URGENT FIELD SAFETY NOTICE

Leica M525 OH4 / Leica M720 OH5 Surgical Microscopes with 400W Illumination

FSCA-Identifier: CAPA-2015-12-001-H

Replacement of cables in illumination unit required

Picture 1: showing a Leica M525 OH4 surgical microscope with marked illumination units, location of ventilation opening for both illumination units and location of the "Change Lamp" button.
This picture is also representative for Leica M720 OH5.

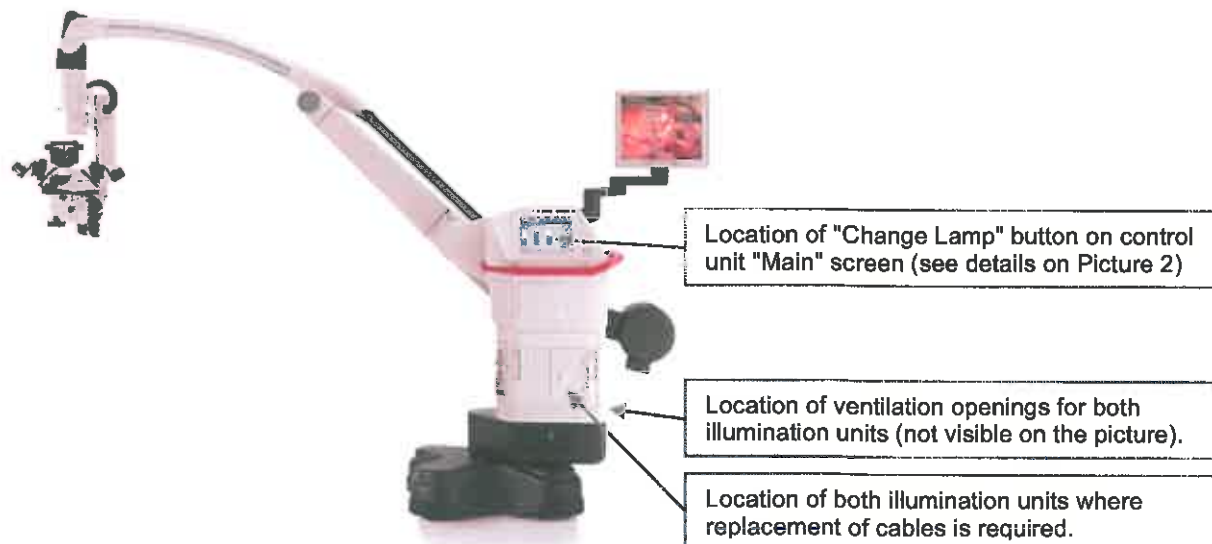
An electronic component in one of the two illumination units can potentially overheat, resulting in minimal smoke and odor emanating from the ventilation openings of the illumination units. The illumination units are located opposite and away from the surgeon / patient side of the surgical microscope (for details see picture 1 below).

In-depth investigation of these reported issues revealed that the root cause is caused by an output filter capacitor in the 400W Xenon Power Supply inside the illumination units. Replacing the power supply output cable of the illumination unit with an improved cable including a filter coil will prevent this failure.

A Leica Microsystems representative will be contacting your facility to arrange the no-cost replacement of the power supply output cables with improved cables including a filter coil in both 400W illumination units of your instrument as soon as possible.

Picture 2: showing the "Main" screen with the "Change Lamp" button marked with a circle.

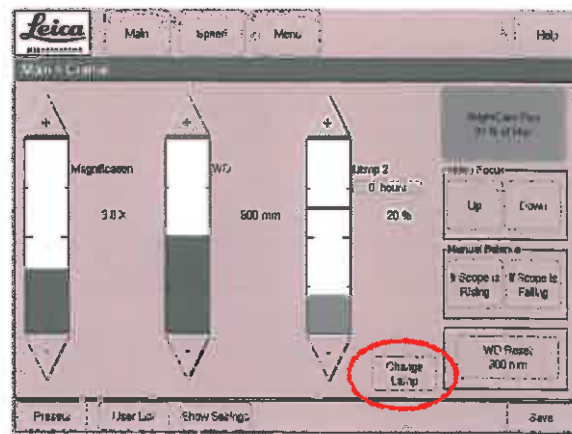
Independent from the issue explained previously, please be reminded that if you notice a failure in the illumination unit you are currently using, switch to the back-up illumination at the next opportunity during surgery by using the "Change Lamp" button on the control unit "Main" screen (see Picture 2 below) as described in user manual.

Changing lamps will interrupt the illumination for less than 5 seconds.

Contact your Leica Microsystems representative for repair of the defective illumination unit before using the instrument for the next surgery.
